FEDERAL Project No. ARRA-N050(301)

**4'x6'-6" Reinforced Concrete Manhole Details**  
(Upstream Manhole Shown)

**Line 3**

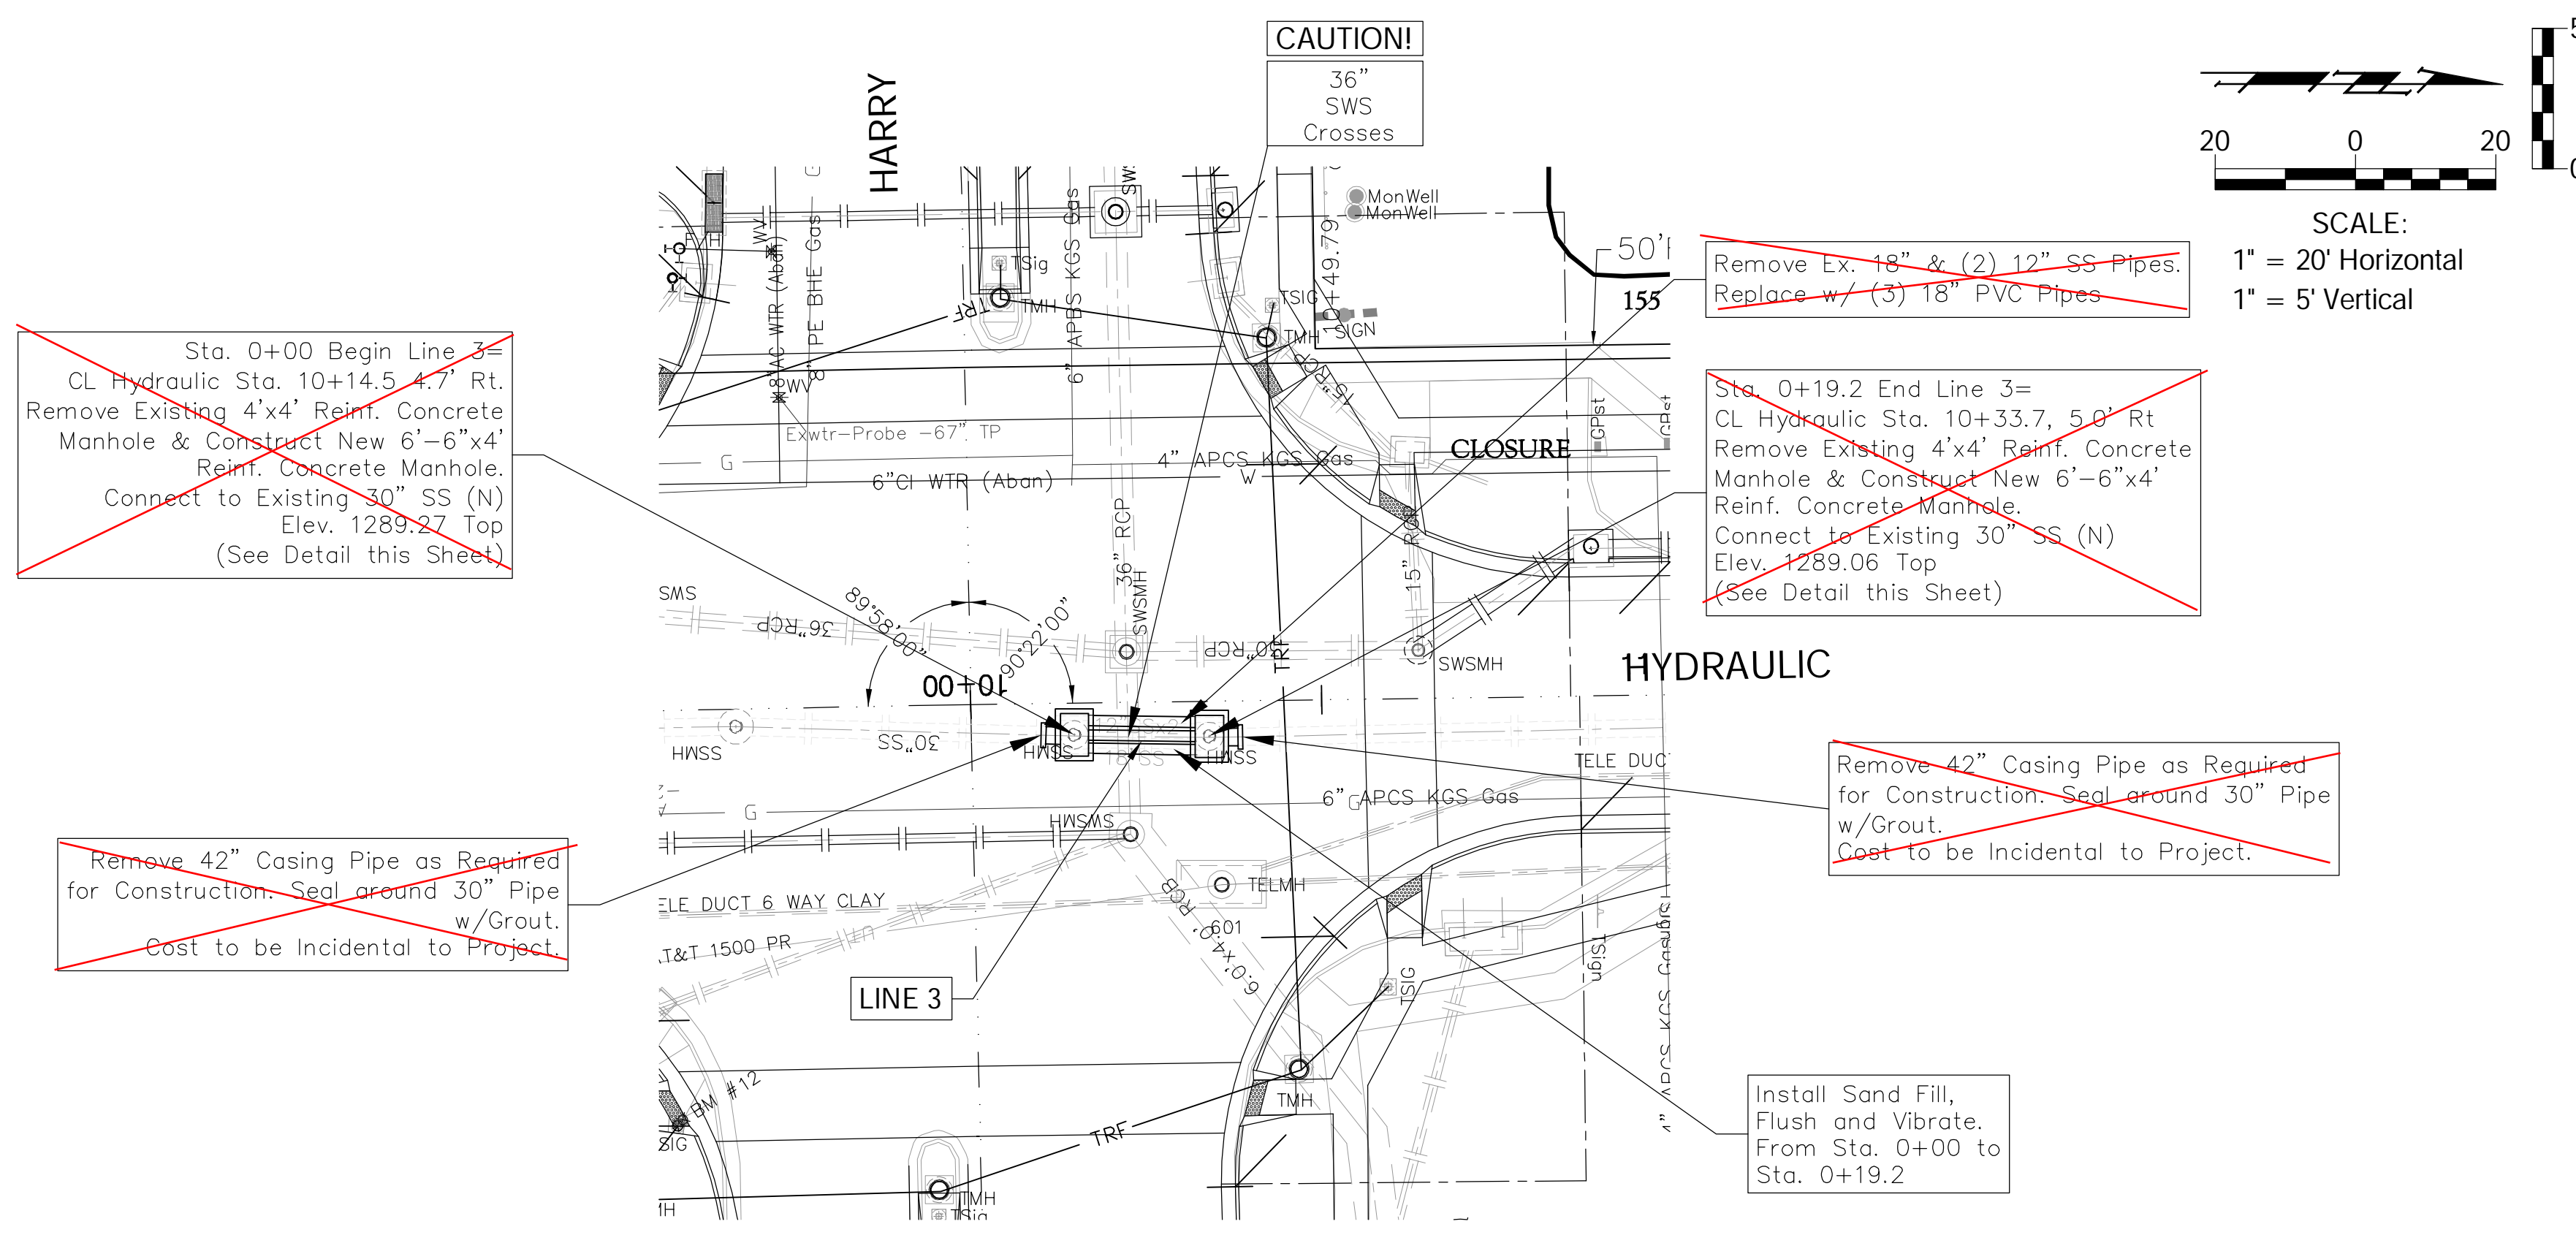
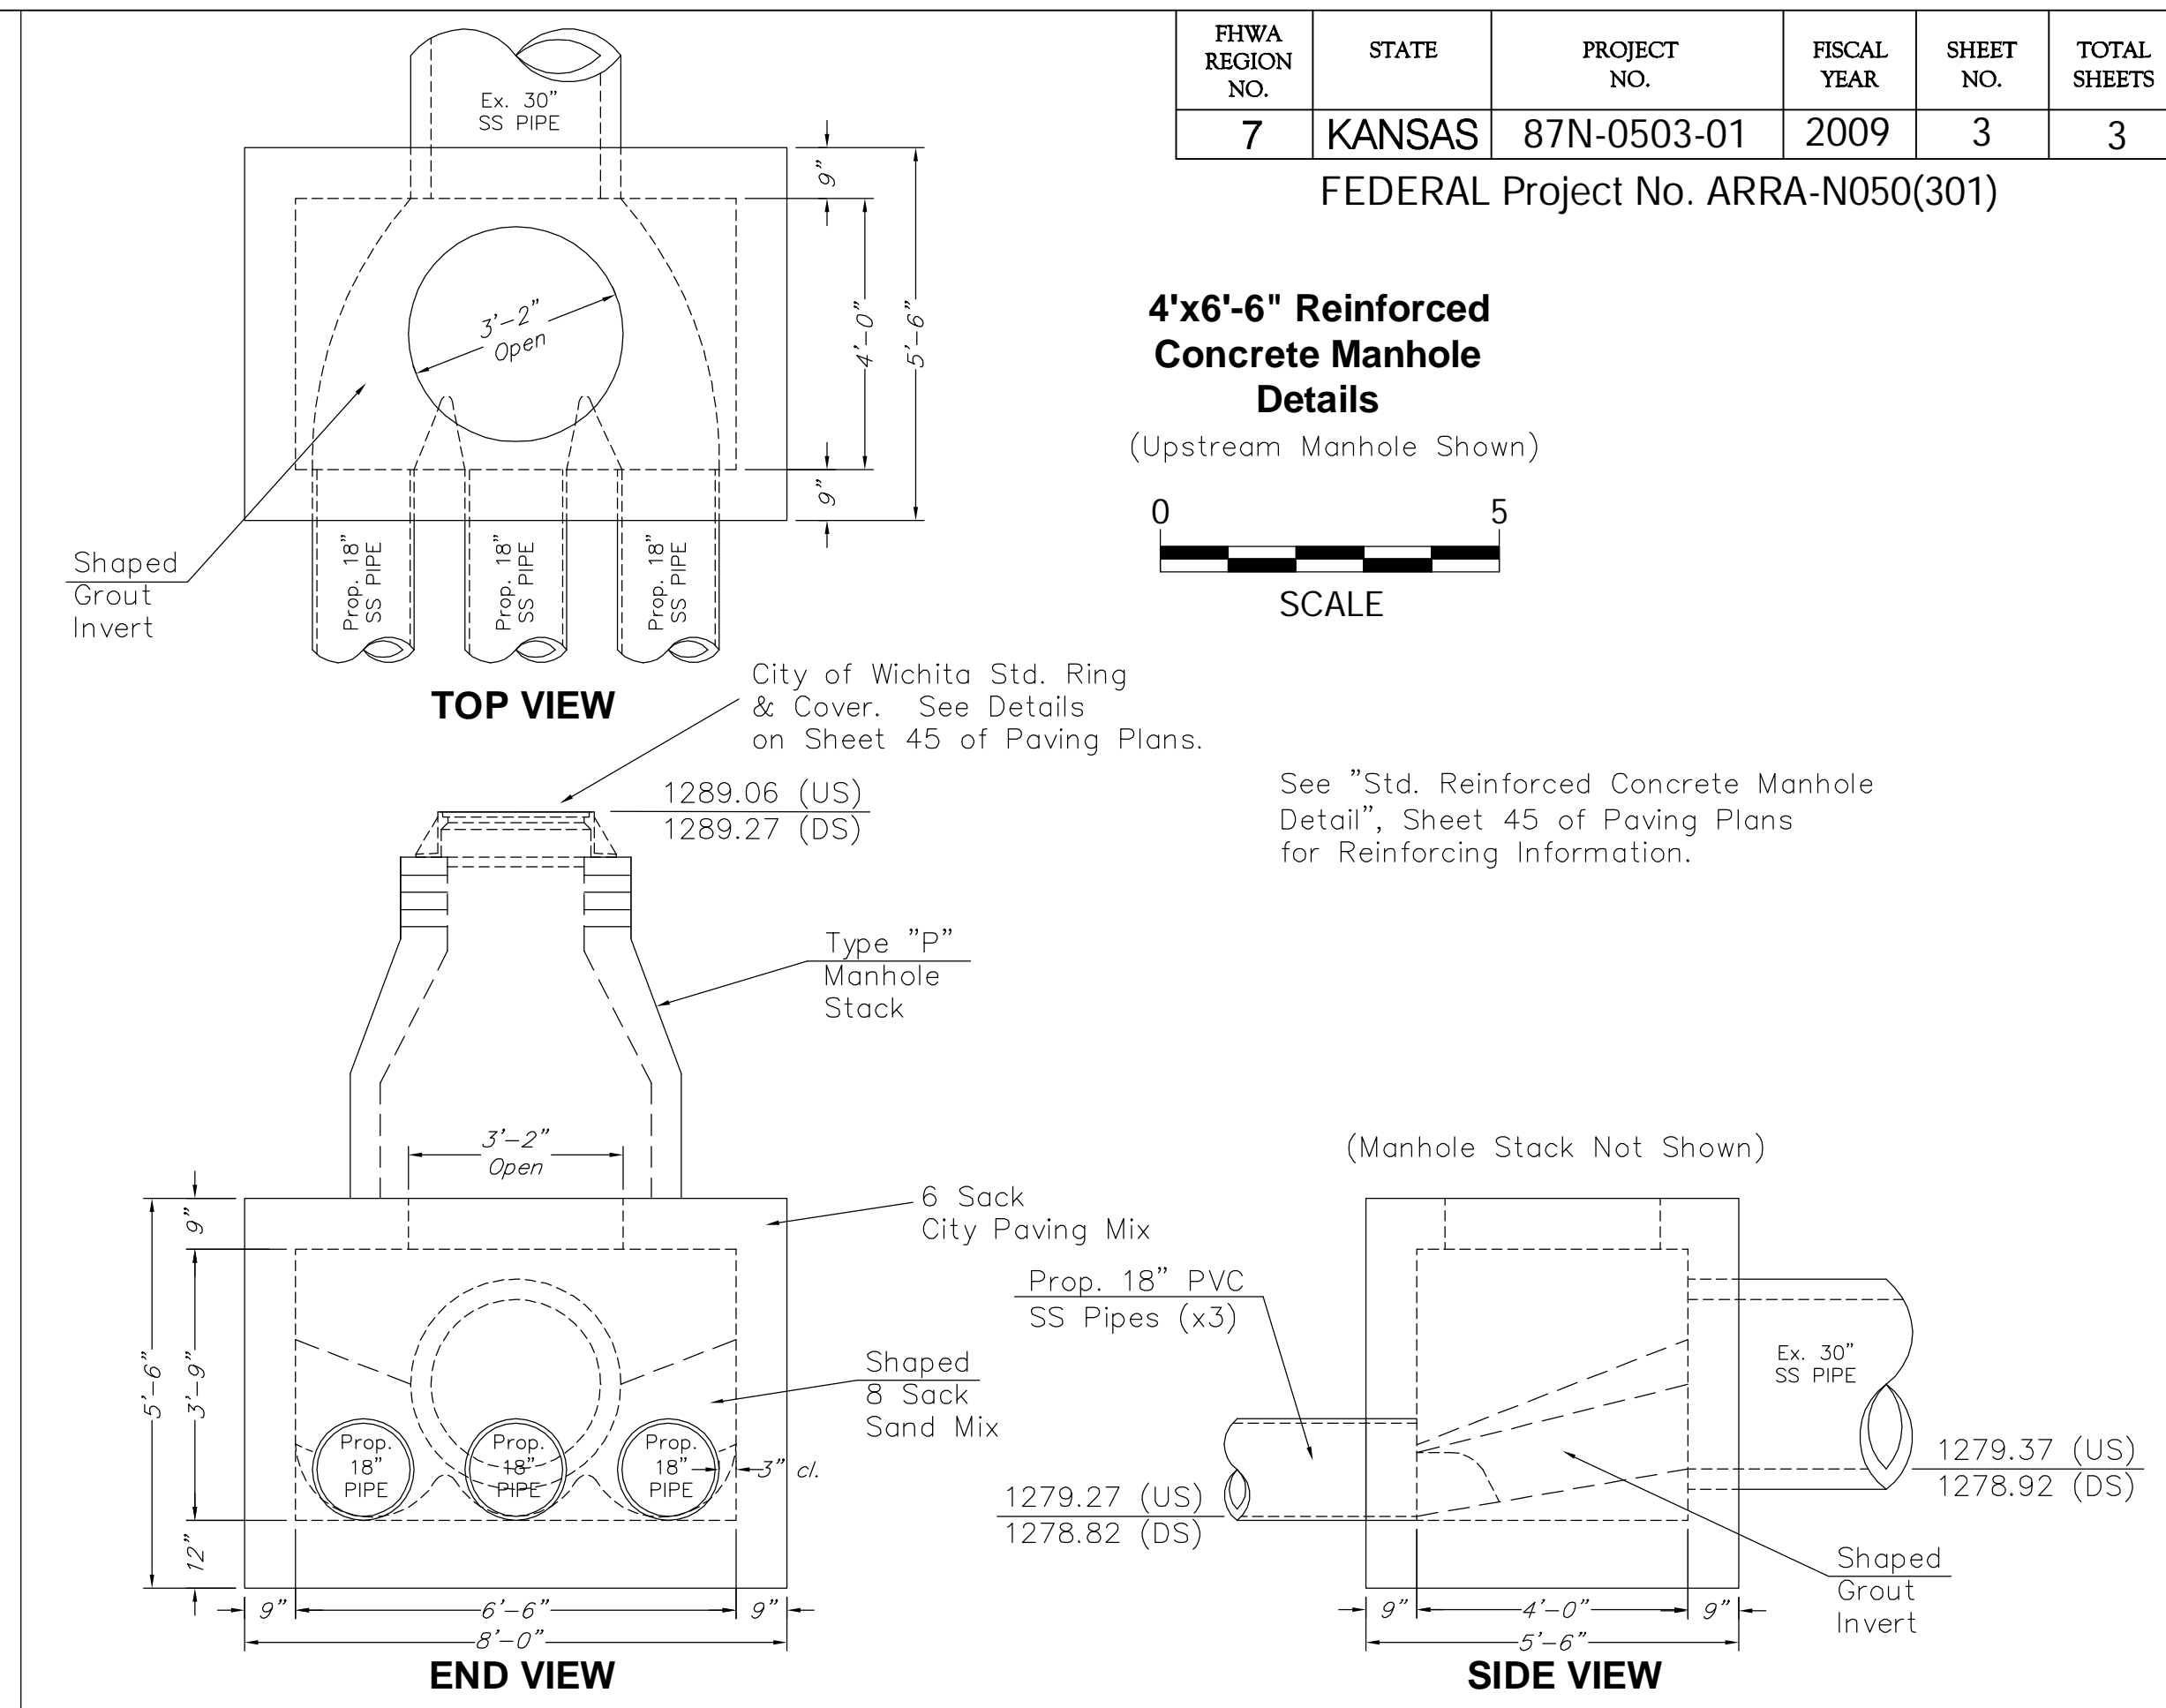
**NO RECONSTRUCTION DONE DUE TO CONFLICT ON SS & SWS. SS LINED WITH CIPP (See Change Order #2)**
